Status: MANDATORY

Models and Serial Numbers: Jabiru 3300 Tri Gear Configurations

Reference Number: SNX-SB-007

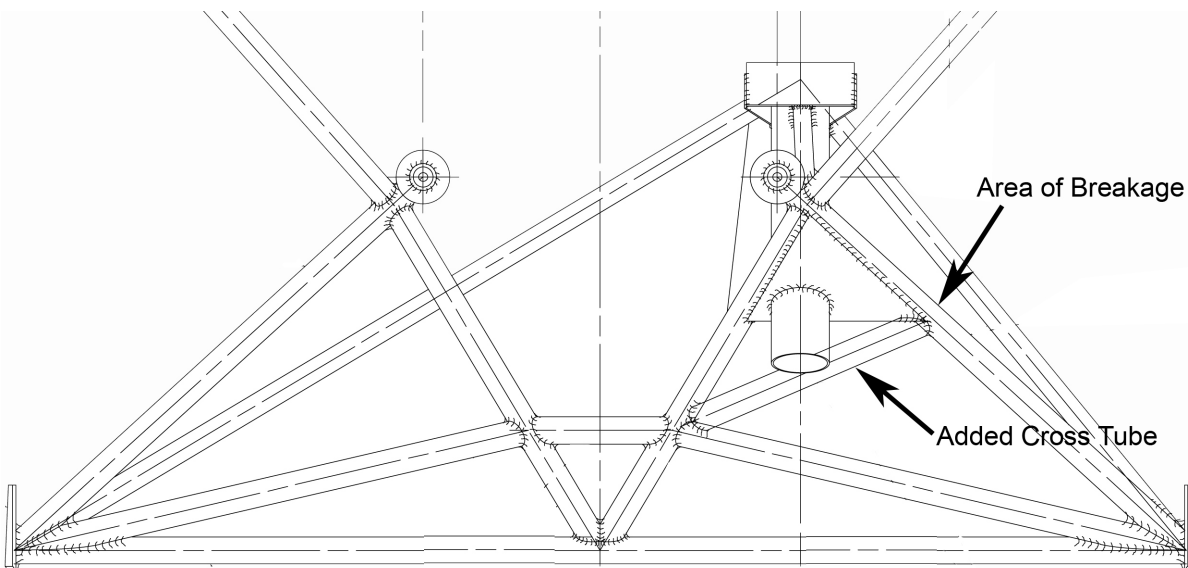
Sonex Aircraft has received reports of the tri-gear Jabiru 3300 engine mounts breaking where the outer tube interfaces with the triangular bracket that supports the nose gear strut.

All tri-gear Jabiru 3300 motor mounts must be checked prior to your next flight with a particular emphasis on the area where the tubes interface with the triangular nose strut gusset. This should be continuously checked at regular intervals after that, such as at oil changes, 25, 50, and 100 hour inspections and during the Condition (Annual) Inspection.

This area must also be inspected immediately if nose wheel vibration is detected, a hard landing is experienced, after rough field operation, or if the nose strut is stressed sideways from improper ground handling.

Any crack found must be repaired prior to your next flight.

Sonex Aircraft has upgraded all new production Tri-Gear Jabiru 3300 motor mounts (identified on the plans, on packing lists, and by part label as part number SNX-P22-10) to include an additional tube. This tube, made of 3/4" diameter x .035" wall 4130 steel tubing can be added to all existing motor mounts.

The tube must be welded in place using accepted aircraft welding and repair practices.
